Staff Report

Re: PLNPCM2021-00847 – LaraDean Townhomes Planned Development

PLNSUB2021-00848 – LaraDean Townhomes Preliminary Subdivision

PLANNED DEVELOPMENT & PRELIMINARY SUBDIVISION

LANDSCAPE SITE PLAN

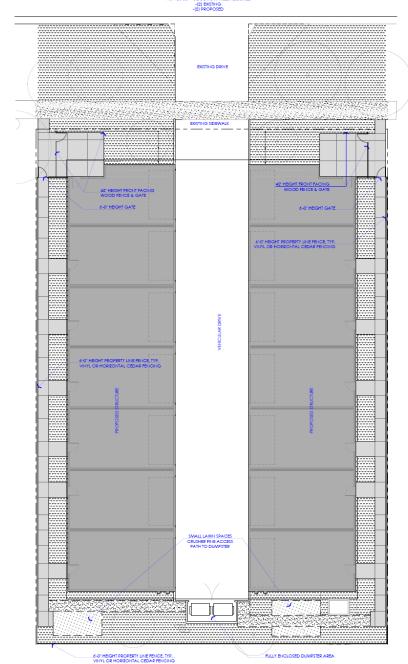
Urban Forestry is good with the species chosen for the park strip. It should be noted that a Tree Protection Zone (TPZ) must be depicted on demolition and construction drawings and will be required to be established around the existing Mackia trees in the park strip, prior to the start of demolition and must be left in place through the end of construction. A planting permit will also be required from our department for the proposed Linden in the park strip, prior to the approval of the building permit.
